Project	IEEE 802.16 Broadband Wireless Access Working Group < http://ieee802.org/16 >
Title	OFDMA PHY Enhancements for better mobility performance
Date Submitted	2004-03-18
Source(s)	<p>John Liebetreu, Jeff Foerster, Jose Puthenkulam Randall Schwartz, David Johnston, Hassan Yaghoobi, Intel Corporation</p> <p>Yossi Segal, Yigal Leiba, Zion Hadad, Runcom Technologies Ltd.</p> <p>Panyuh Joo, Seungjoo Maeng, Jaeho Jeon, Soonyoung Yoon, Jeong-Heon Kim, Jaehyok Lee, Inseok Hwang, Jaehee Cho, Jiho Jang, Samsung Electronics Co. Ltd.</p> <p>Naftali Chayat, Tal Kaitz, Mohammed Shakouri, Alvarion Ltd.</p> <p>Shawn Taylor, Wi-LAN Inc.</p> <p>J. Pierre Lamoureux, Frank Draper, Wavesat Inc</p> <p>Martin Lysejko, Airspan</p> <p>Raja Banerjea, Don Leimer, Proxim Inc</p> <p>Phil Barber, Broadband Mobile Technologies</p> <p>Dale Branlund, Lalit Kotecha, Mike Webb, BeamReach Networks</p>
Re:	Task Group Review of IEEE P802.16-REVd/D2-2003

Abstract	Changes to OFDMA PHY
Purpose	Adoption
Notice	This document has been prepared to assist IEEE 802.16. It is offered as a basis for discussion and is not binding on the contributing individual(s) or organization(s). The material in this document is subject to

Figure 240—CTC encoder

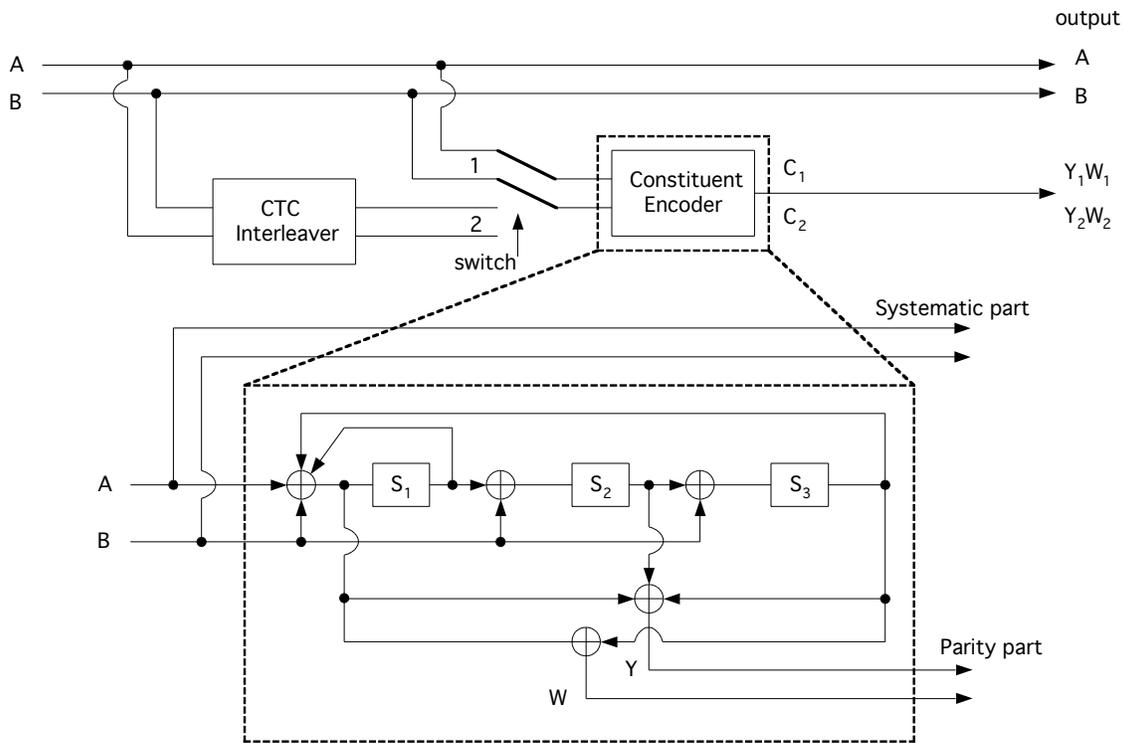
[Replace figure 240 with the figure below]:

The Convolutional Turbo Code defined in this section is designed to enable support of hybrid ARQ (HARQ). HARQ implementation is optional. The Convolutional Turbo Code encoder, including its constituent encoder, is depicted in Figure 240. It uses a double binary Circular Recursive Systematic Convolutional code. The bits of the data to be encoded are alternately fed to A and B, starting with the MSB of the first byte being fed to A. The encoder is fed by blocks of k bits or N couples ($k = 2*N$ bits). For all the frame sizes k is a multiple of 8 and N is a multiple of 4. Further N shall be limited to: $8 \leq N/4 \leq 1024$.

First, the encoder (after initialization by the circulation state Sc_1 , see 8.4.9.2.3.3) is fed the sequence in the natural order (position 1) with the incremental address $i = 0 \dots N-1$. This first encoding is called Sc_1 encoding. Then the encoder (after initialization by the circulation state Sc_2 , see 8.4.9.2.3.3) is fed by the interleaved sequence (switch in position 2) with incremental address $j = 0, \dots, N-1$. This second encoding is called C_2 encoding.

Figure bbb— Block diagram of subpacket generation

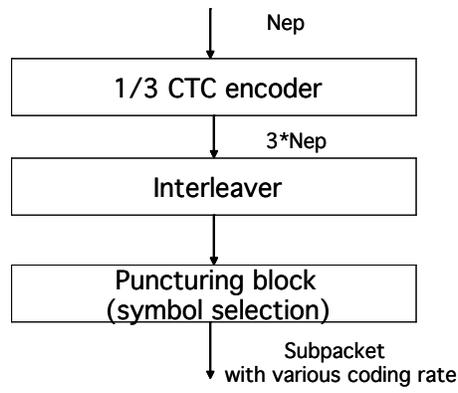
[Delete section 8.4.9.2.3.4 and add the text below instead]:

Proposed FEC structure punctures the mother codeword to generate subpacket with various coding rates. The subpacket is also used as HARQ packet transmission. Figure bbb shows block diagram of subpacket generation. 1/3 CTC encoded codeword goes through interleaving block and the puncturing is performed. The puncturing is performed to select the consecutive interleaved bit sequence that starts at any point of whole codeword. For the first transmission, the subpacket is generated to select the consecutive interleaved bit sequence that starts from the first bit of the systematic part of the mother codeword. The length of the subpacket is chosen according to the needed coding rate reflecting the channel condition. The first subpacket can also be used as a codeword with the needed coding rate for a burst where HARQ is not applied.

Figure ccc— Block diagram of the interleaving scheme

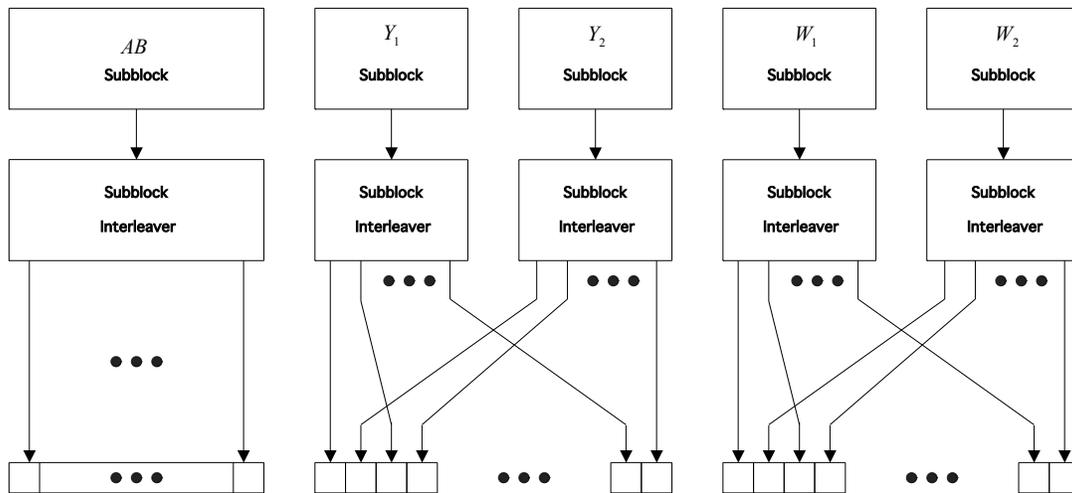
Figure ccc shows block diagram of the interleaving scheme of the proposed FEC structure. At first, the CTC encoder output is separated into a subblock. Then the interleaving is applied for the bit sequence within the subblock. It guarantees the uniformity of the interleaved codeword. Next, Symbol grouping is performed such that the parity bits from the two constituent encoders are interlaced bit by bit. The systematic part of the 1/3 CTC encoder is located at the head of the interleaved codeword. In this way, the proposed FEC structure ensures the quasi complementary characteristics of the interleaved codeword and thus, complementary characteristics of the subpacket. We just say “quasi complementary” for the case of breaking the complementariness of few bits after puncturing.

Figure eee—Construction of H-ARQ encoder packet

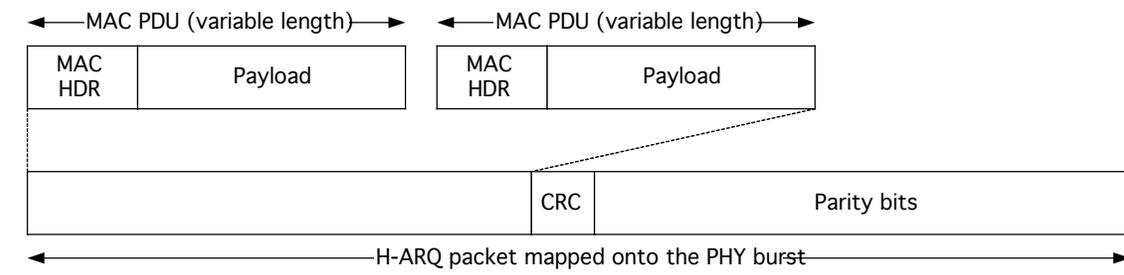
[Add the text below to a new section after 6.4.15]:

One or more MAC PDUs can be concatenated and an H-ARQ packet formed by adding a CRC to the PHY burst. Figure eee shows how the H-ARQ encoder packet is constructed.

Figure hhh—Description of an uplink tile

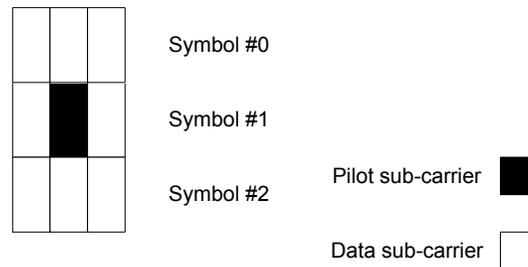
[Add a new section after section 8.4.6.2.3]:

A burst in the uplink is composed of 3 time symbols and 1 subchannel, within each burst, there are 48 data subcarriers and 6 fixed-location pilot subcarrier. Tile configuration is illustrated in Figure 223.
